CONVAIR

COMMERCIAL CHANGE PROPOSAL

SPEC NO.: ZD-22-327 DATE: _____

TITLE: Specification Administrative Change (Revision to Portable Oxygen Bottle Part Number - Group C Airplanes)

Page 50a - PITOT STATIC SYSTEM - ILLUSTRATION:

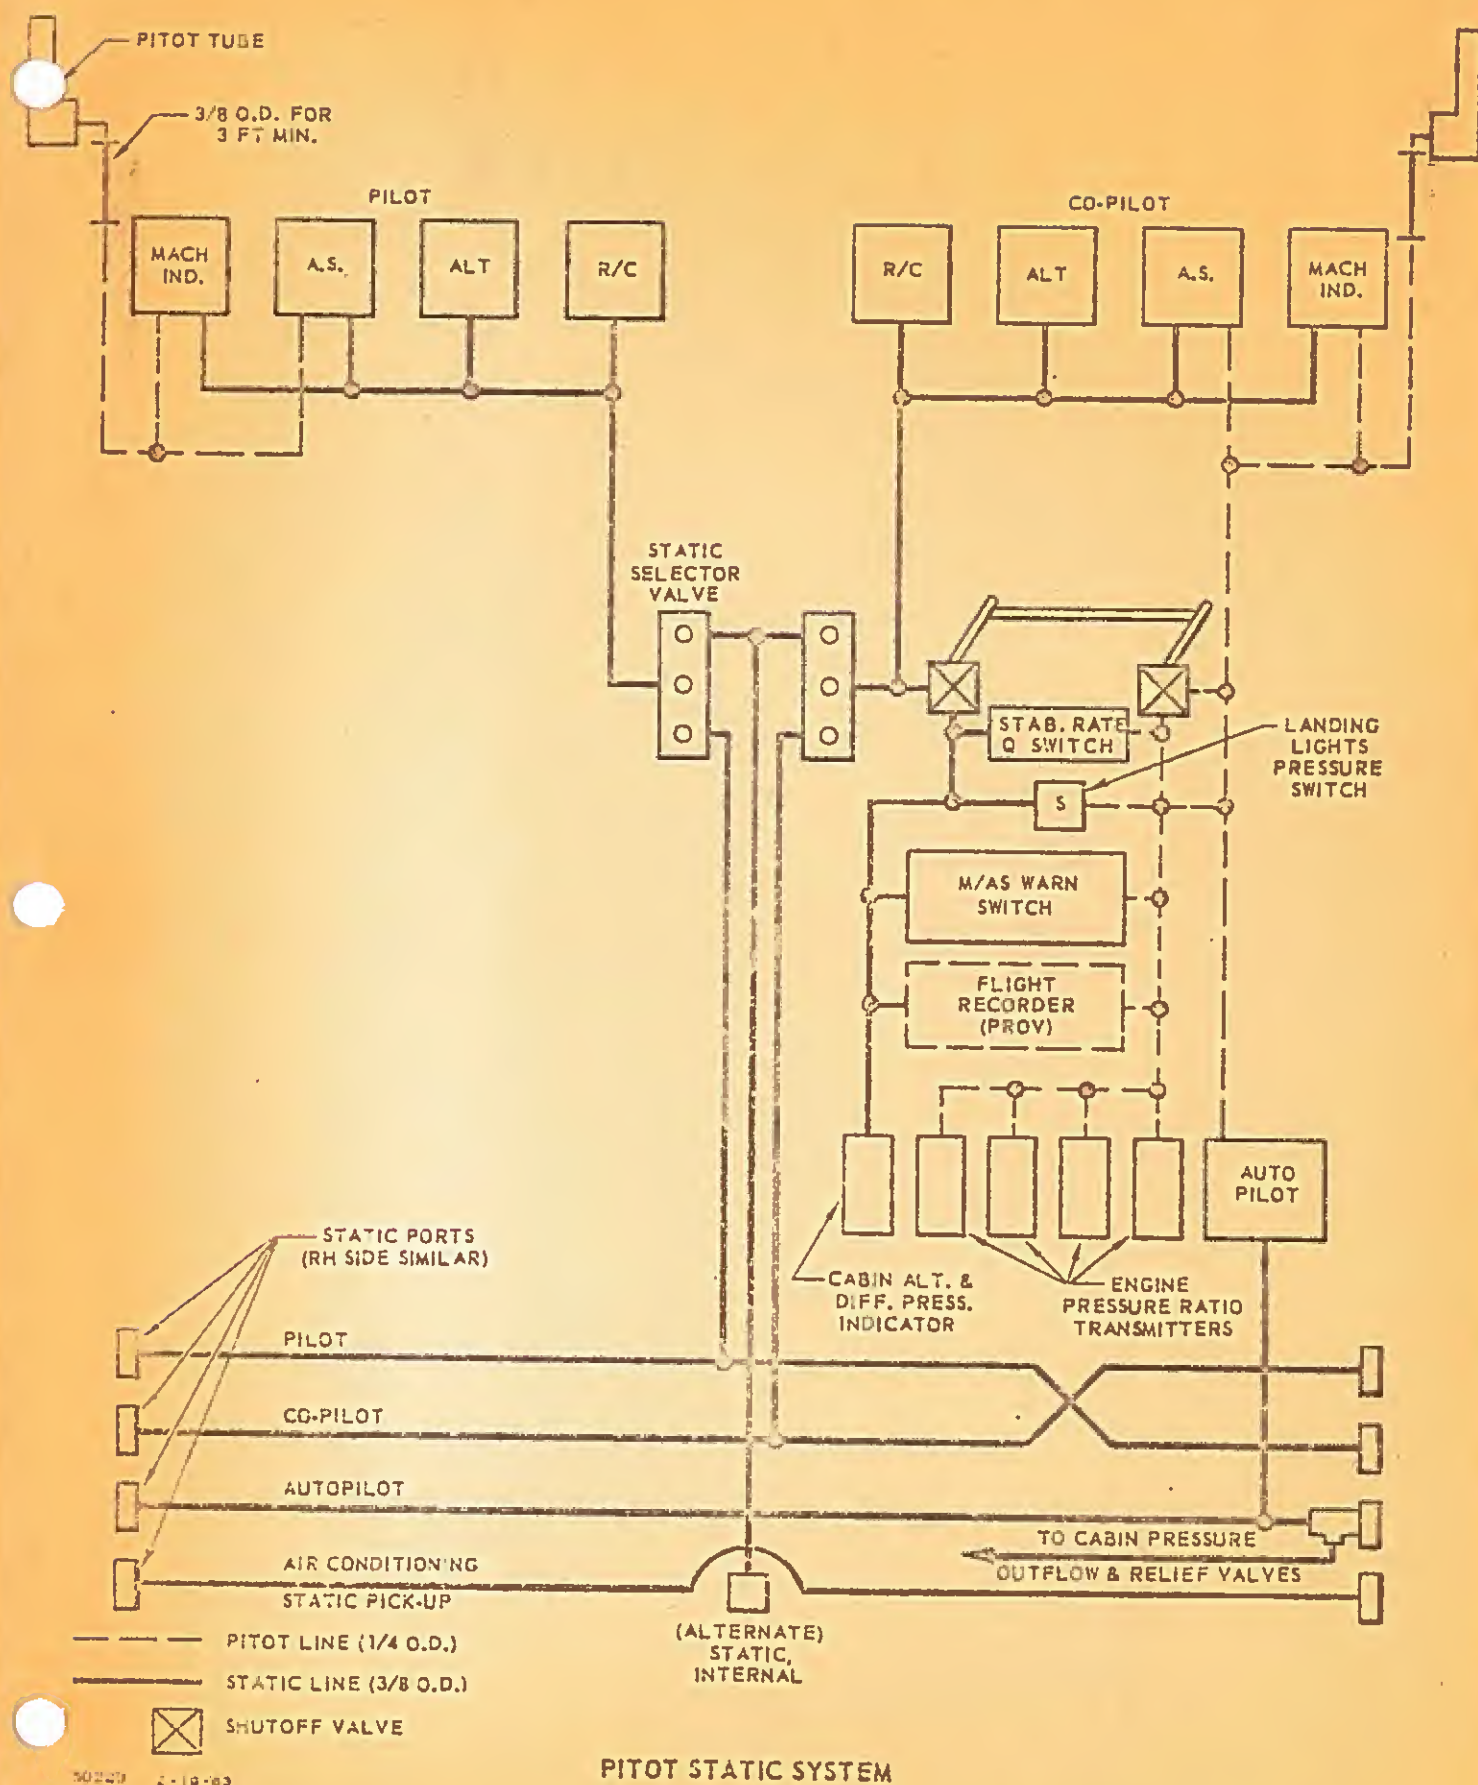
Reason for Change: To up-date pitot static system to show separation of static sources for cabin outflow valves and cabin controller.

Replace above illustration in the specification with attached revised illustration to show current changes.

Page 46a - PITOT STATIC SYSTEM - ILLUSTRATION:

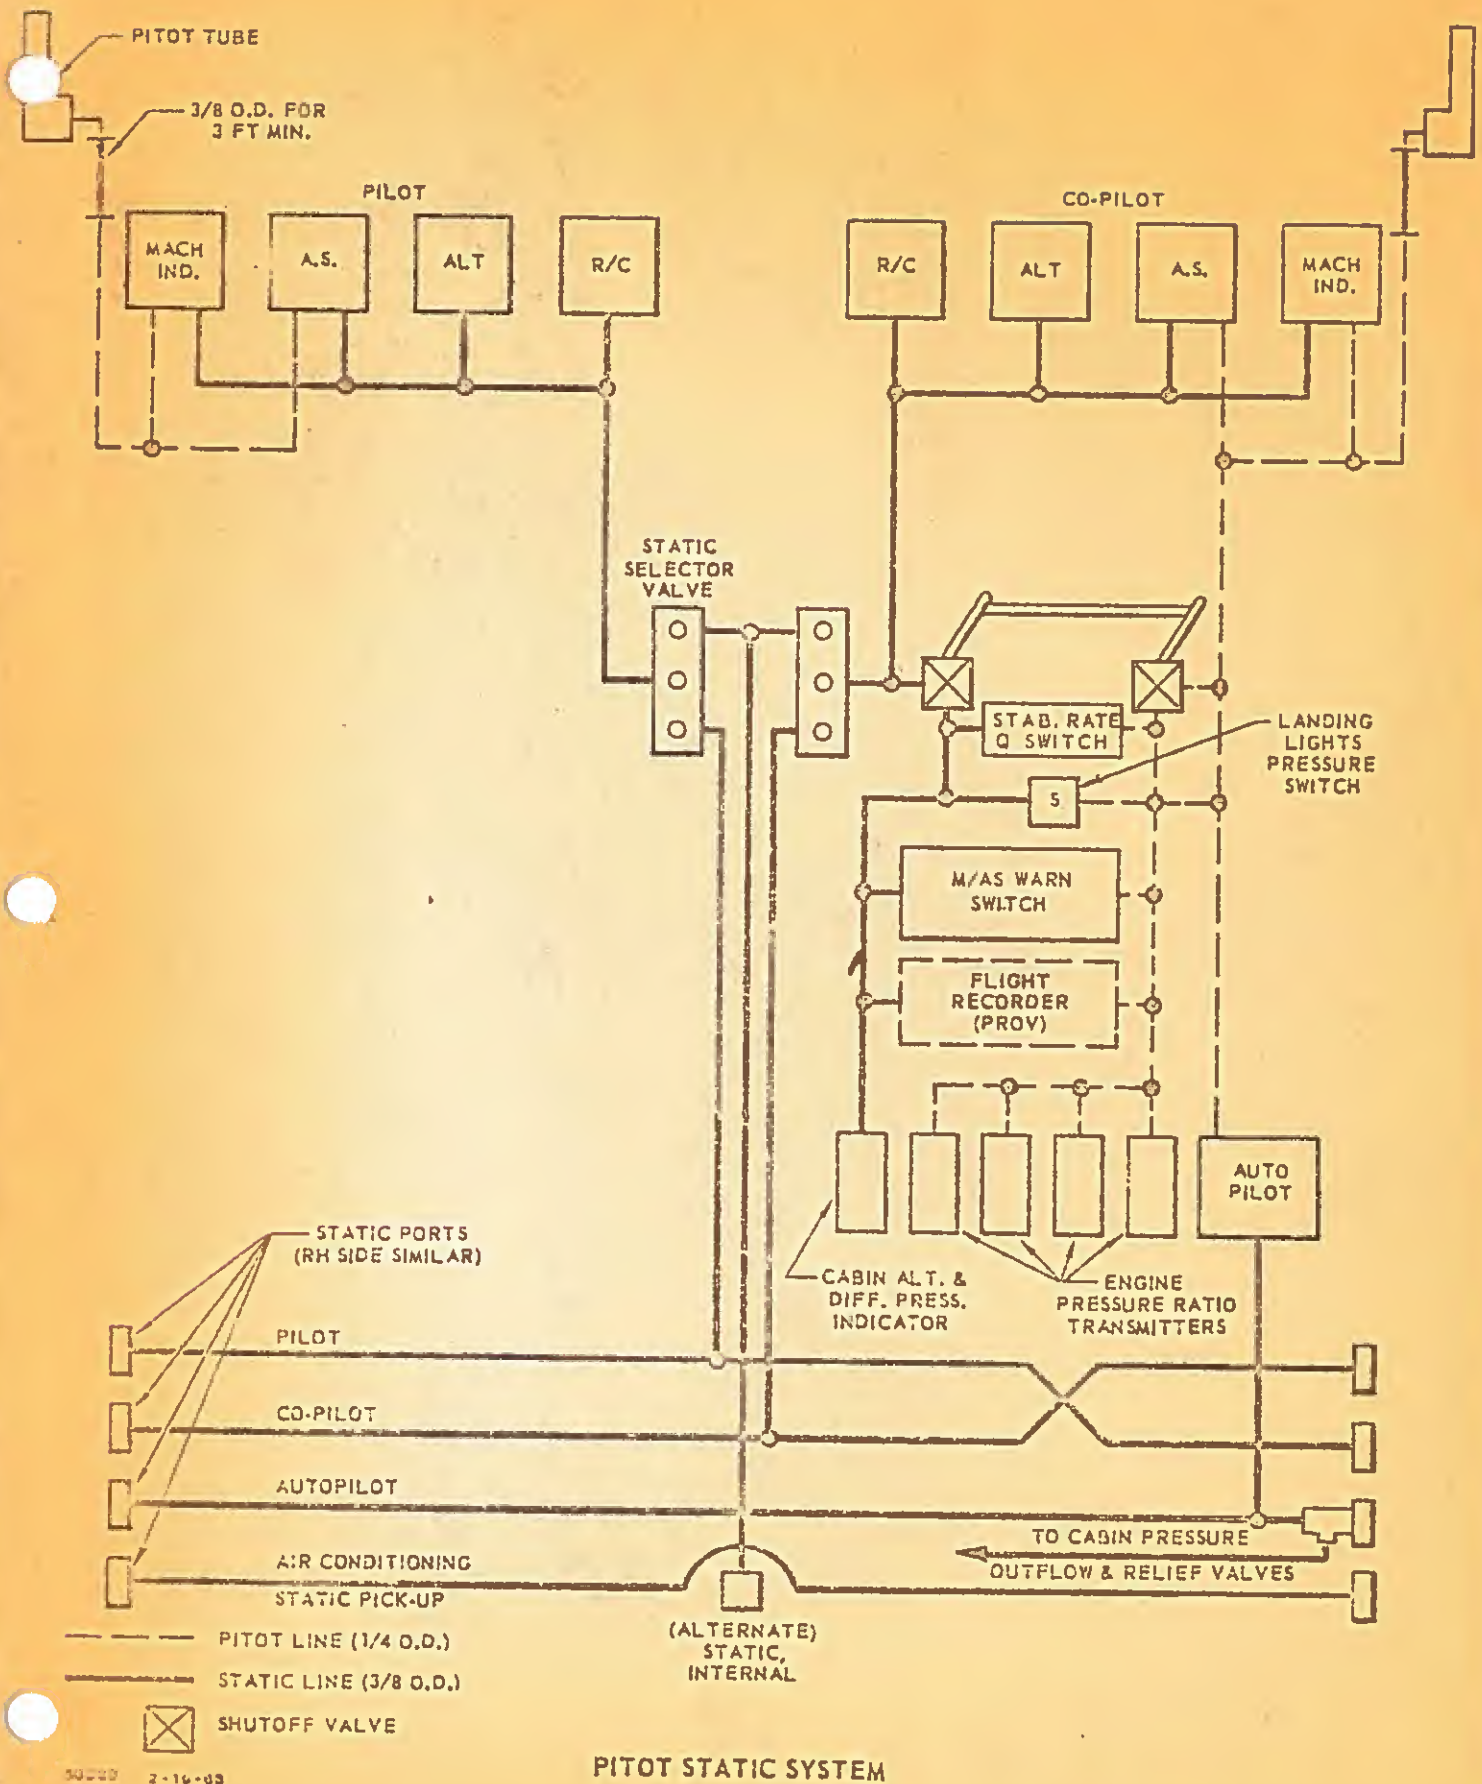
Reason for Change: To up-date pitot static system to show separation of static sources for cabin outflow valves and cabin controller.

Replace above illustration in the specification with attached revised illustration to show current changes.

PILOTS AND COPILOT'S INSTRUMENT PANELS
JAPAN
(EFFECTIVE SHIPS 4 AND 5)

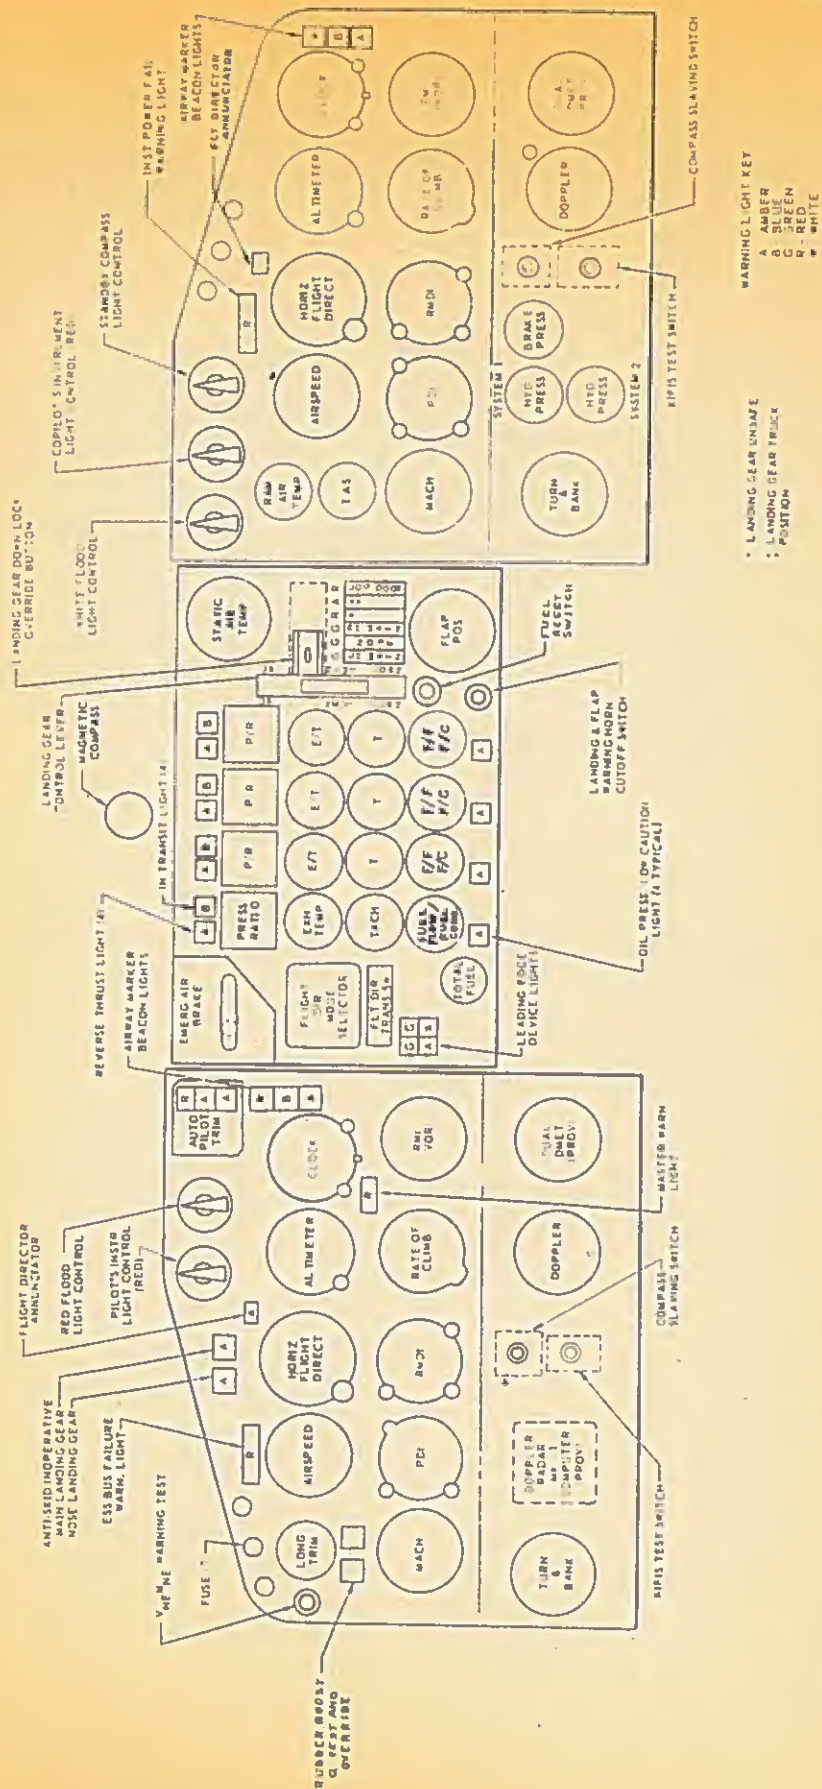
Add the above illustration which shall show ship effectivity 4 and 5, and the installation of Doppler indicator.

PILOT'S AND CO-PILOT'S PEDESTAL

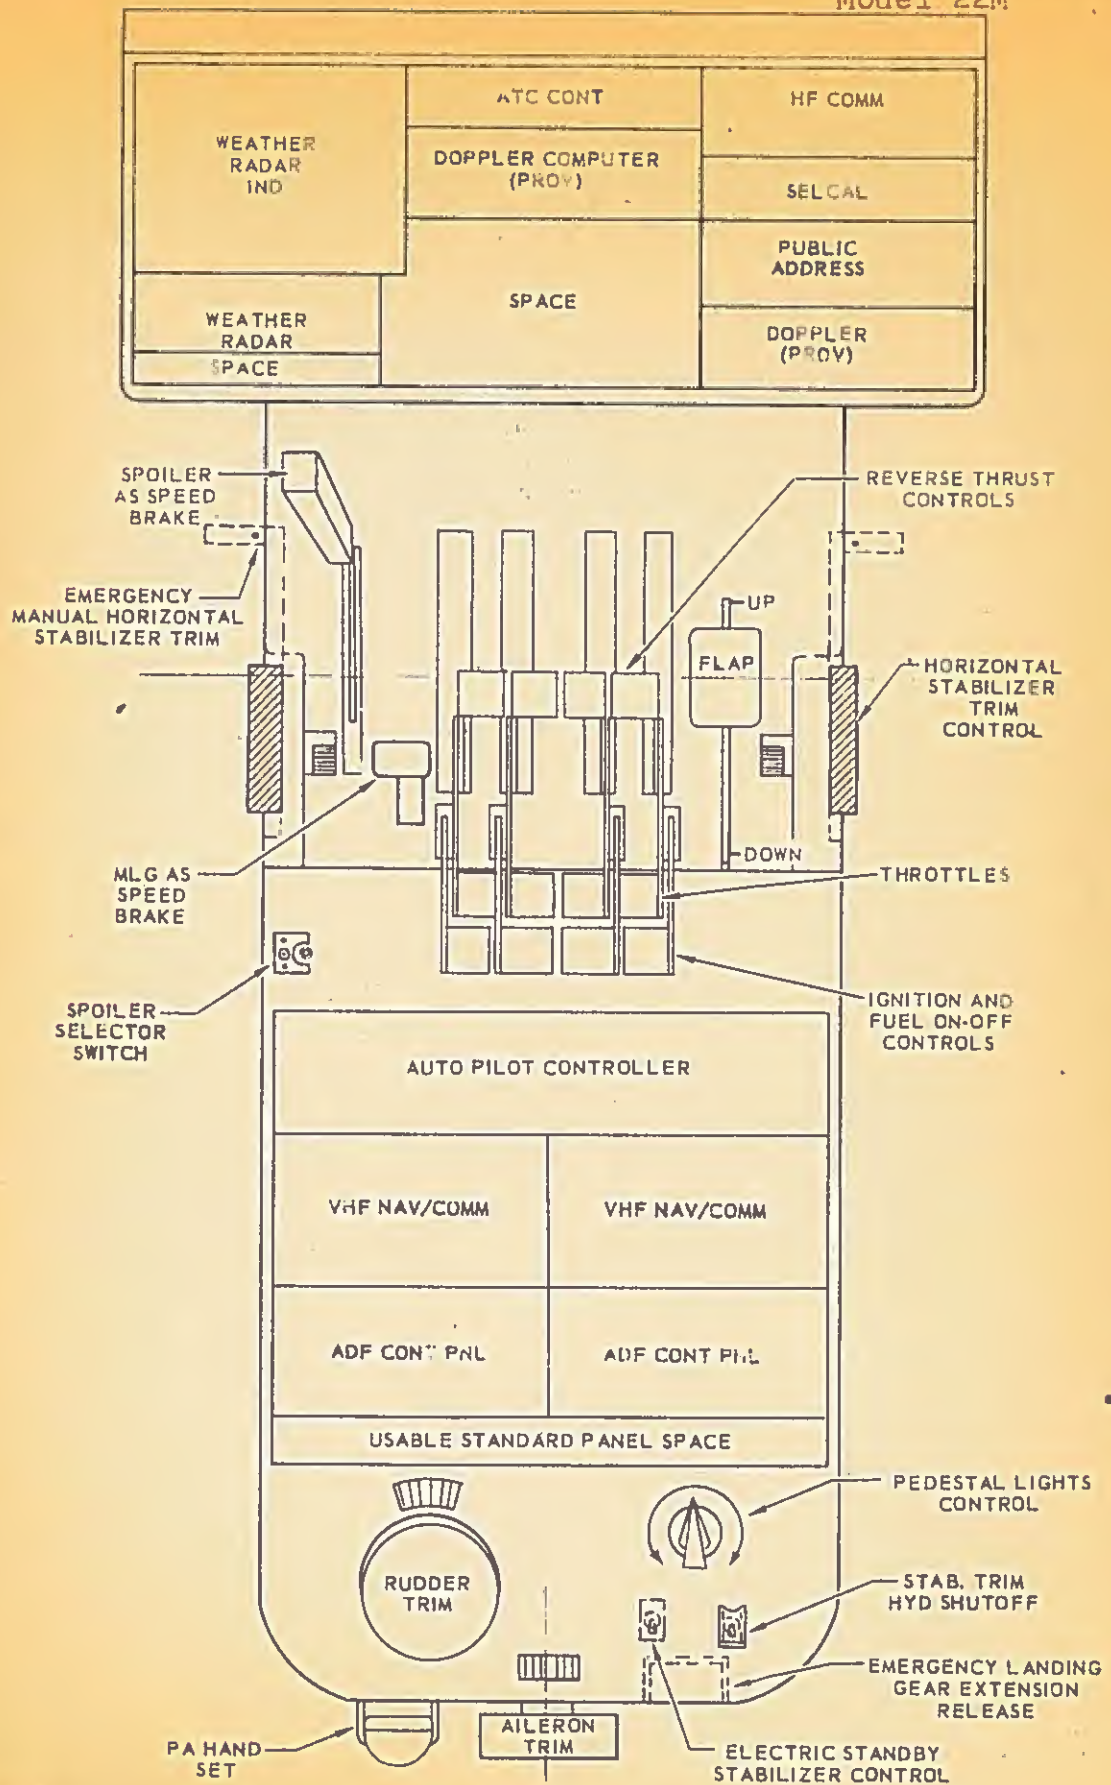
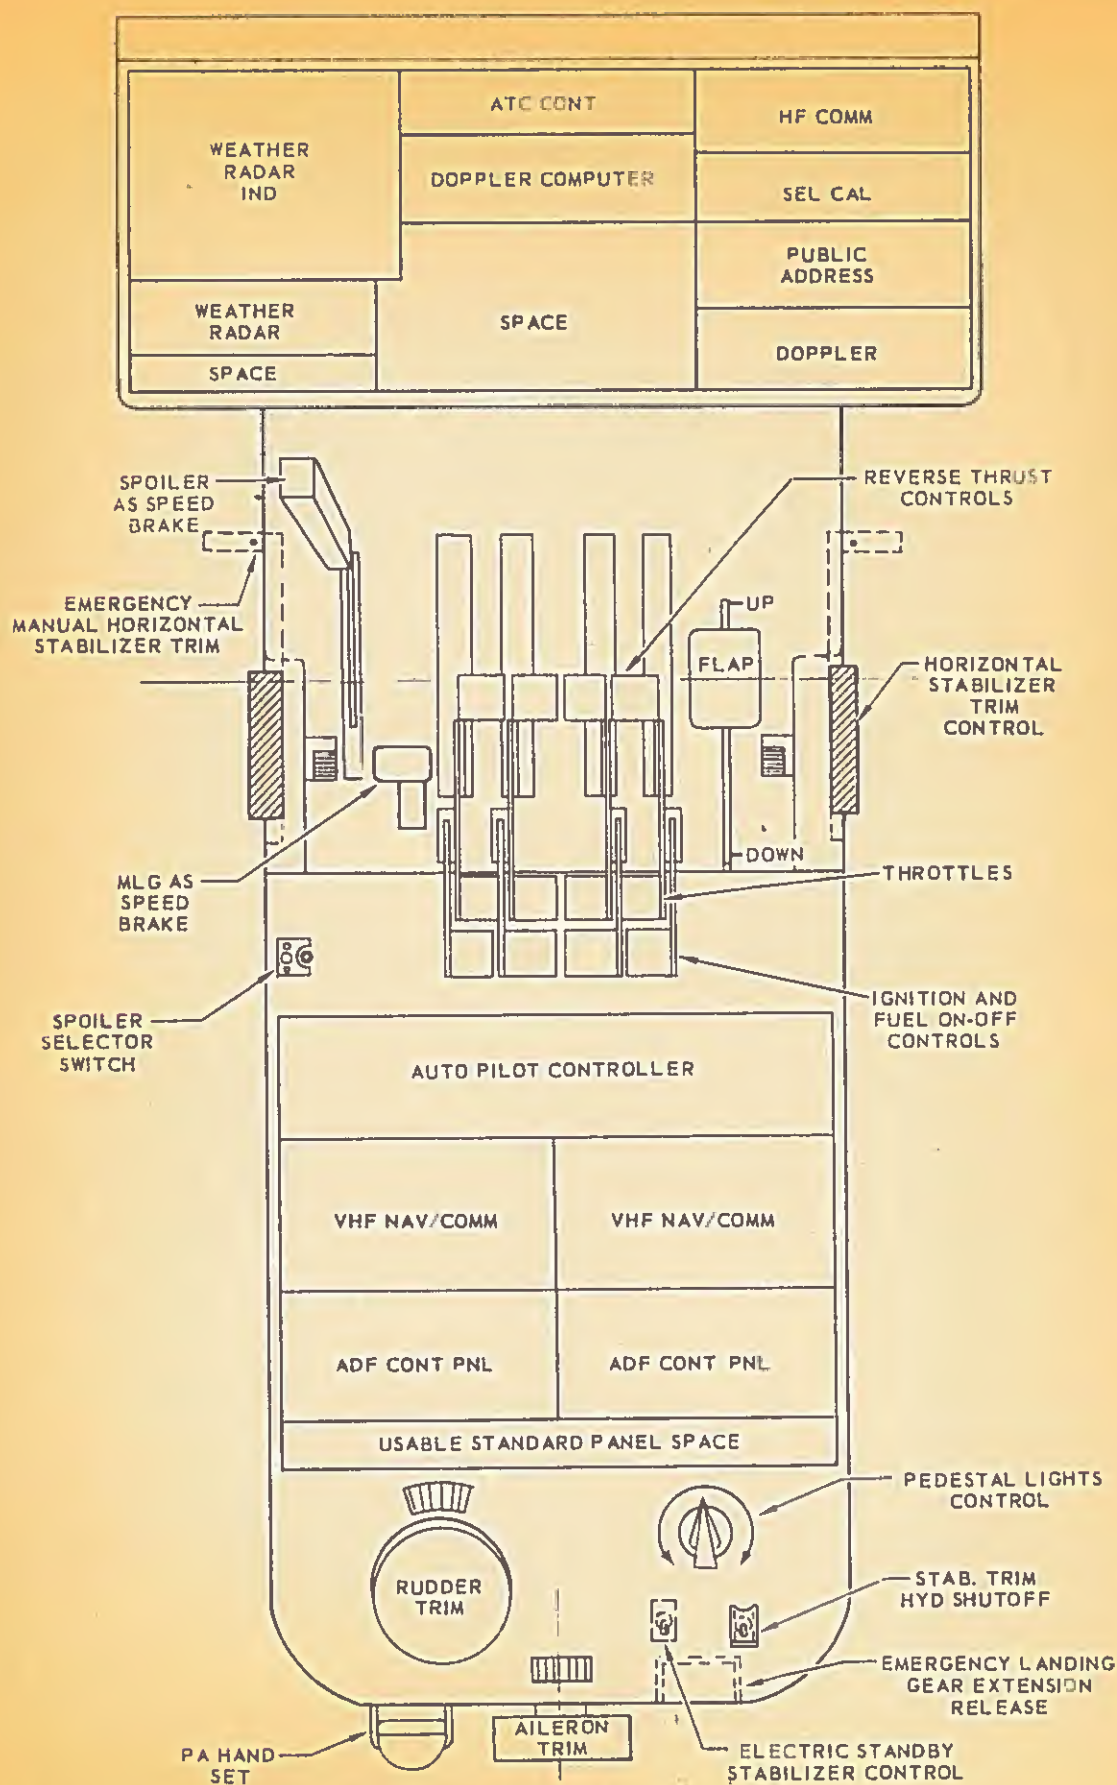
Revise above illustration to show ship effectivity 1, 2 and 3.

Add the above illustration which shall show ship effectivity 4 and 5, and the installation of a Doppler computer control panel.
